Recommendation Meeting

3020 NE 45th Street
Seattle, WA 98105

04.10.2023 SDCI #3039169-LU

Requested Code Departure #2

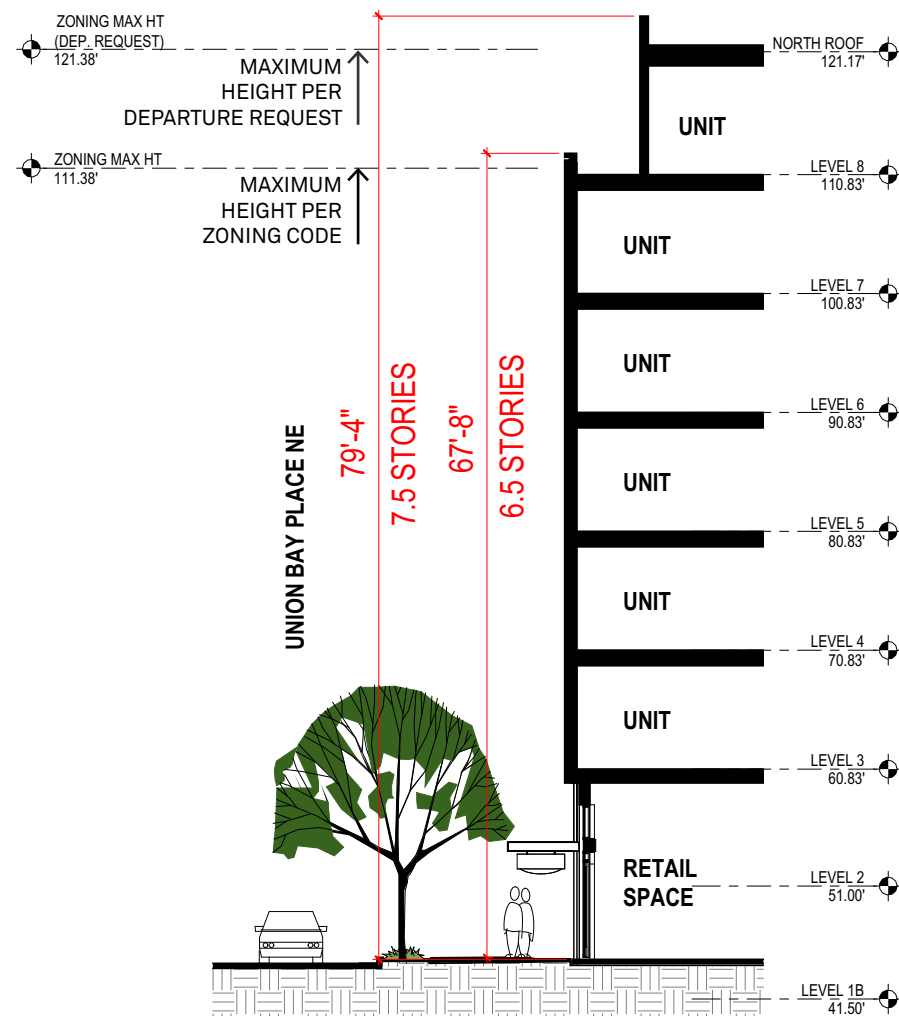
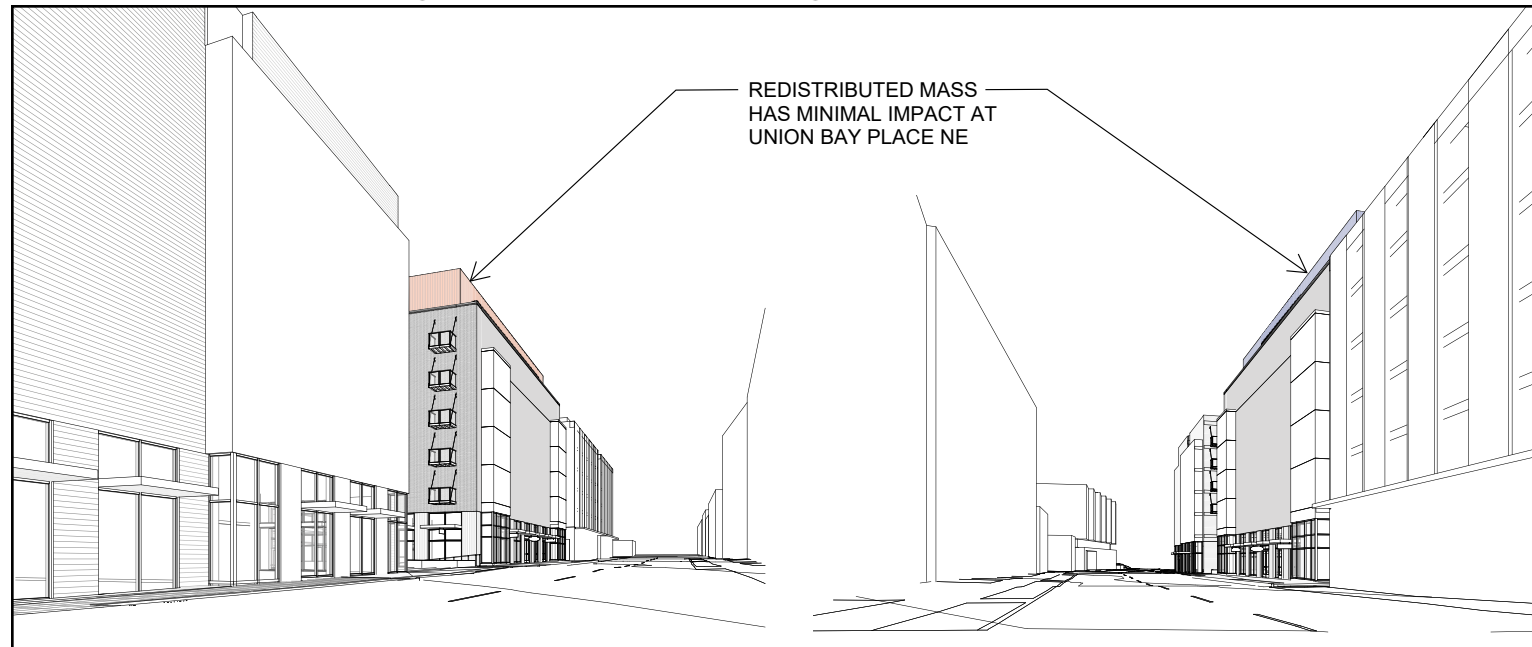
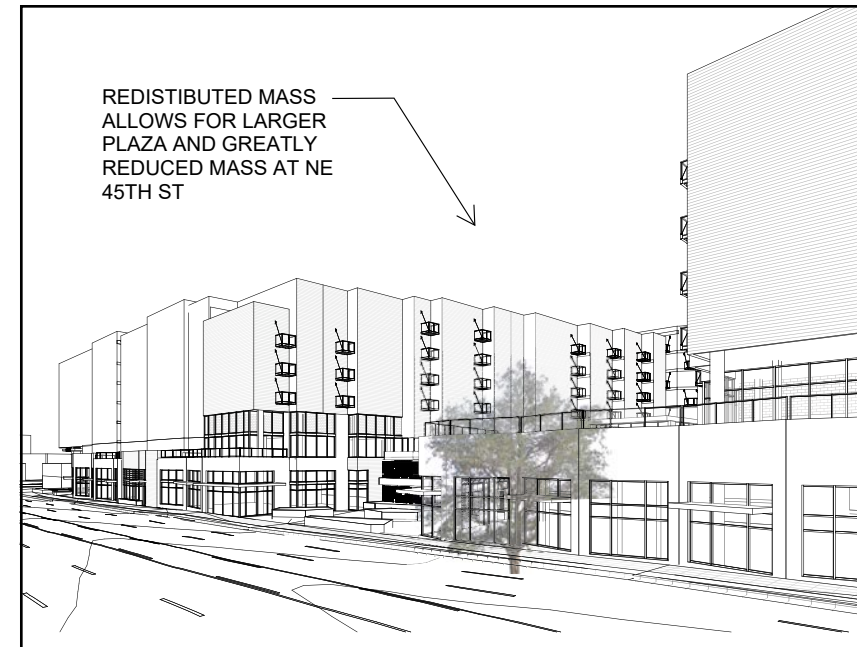
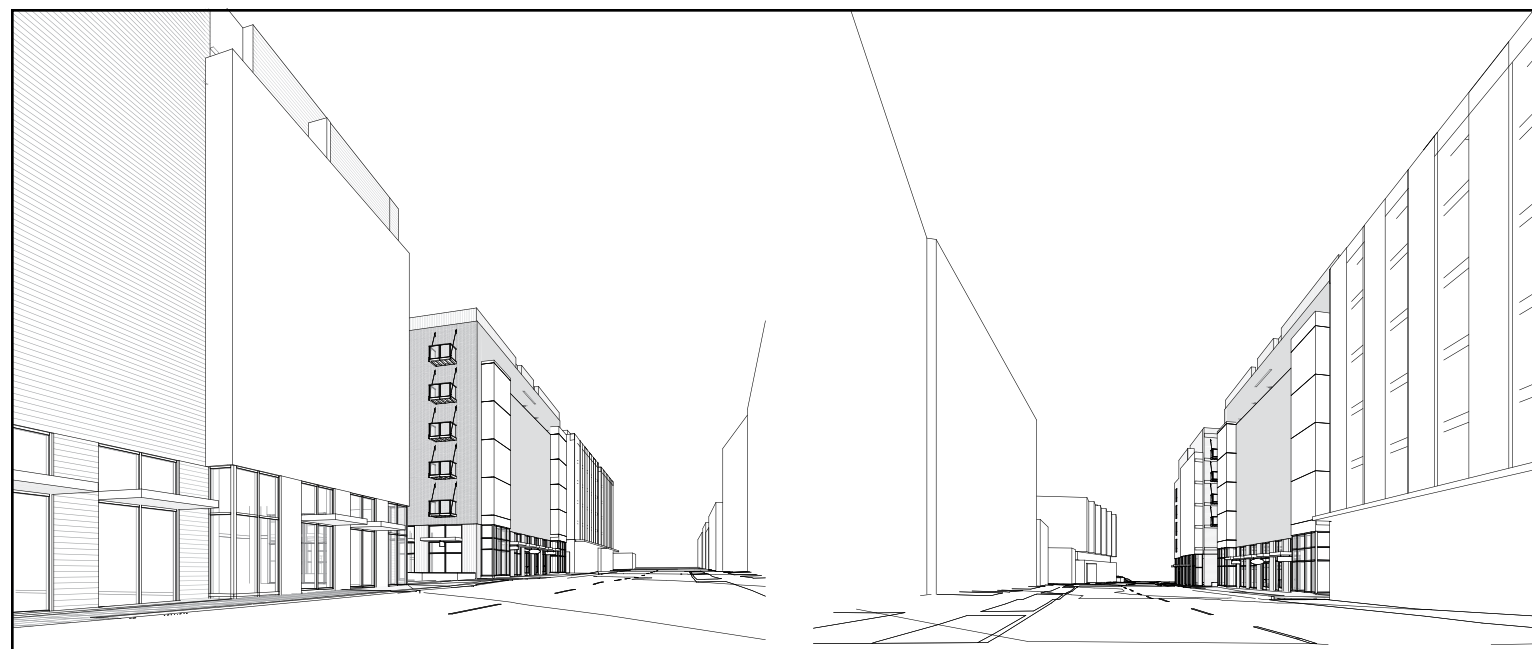
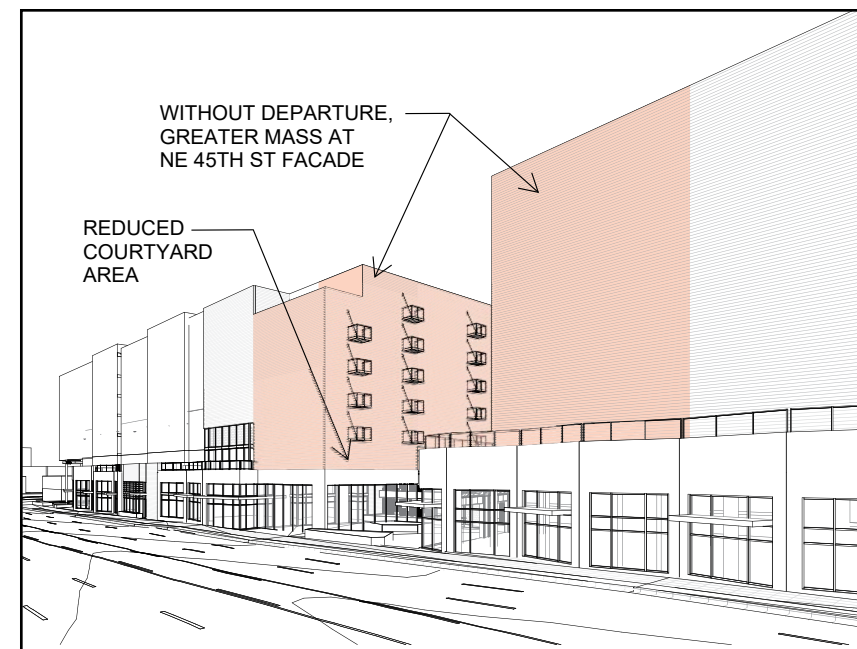
The Board indicated its preliminary support for the departure request given the applicant's rationale about the addition of a floor to the north building which compensates for the reduced footprint necessary to retain the exceptional tree without losing development capacity and the broader opening for the south facing courtyard space. CS2 - URBAN PATTERN AND FORM, DC2-B ARCHITECTURAL AND FAÇADE COMPOSITION, CS2-D HEIGHT, BULK, AND SCALE, CS2-2-b. PROVIDE ZONE TRANSITIONS.

Diagrams have been included on the following pages to demonstrate the zoning height departure request has minimal impact from the pedestrian street level experience and the perceived massing of the building. By allowing the additional height, an additional story would be added to the North Building only, and the project massing would be able to retain two of the four exceptional trees and provide courtyards and a public plaza to promote connectivity with the surrounding neighborhood.

- c. The additional height will allow for an additional floor to be added to one of the three proposed residential buildings on site, which compensates for the reduced footprint necessary to retain the exceptional tree without losing development capacity.

- d. The additional height will be used to add an additional floor to the north residential building ONLY, which is a full story and a half below street level at Union Bay Place NE. This means the perceived height of this building from the street will be only 7.5 stories, less than the 8 story street frontage along NE 45th street, and also similar to what would be achievable if the north building was developed as a stand-alone project without a height variance due to the higher grade along Union Bay Place NE.

- f. The added floor and zoning height departure is not a significant massing impact. Without this departure, the proposed massing will require modifications that eliminates the exceptional tree and reduces the public plaza.
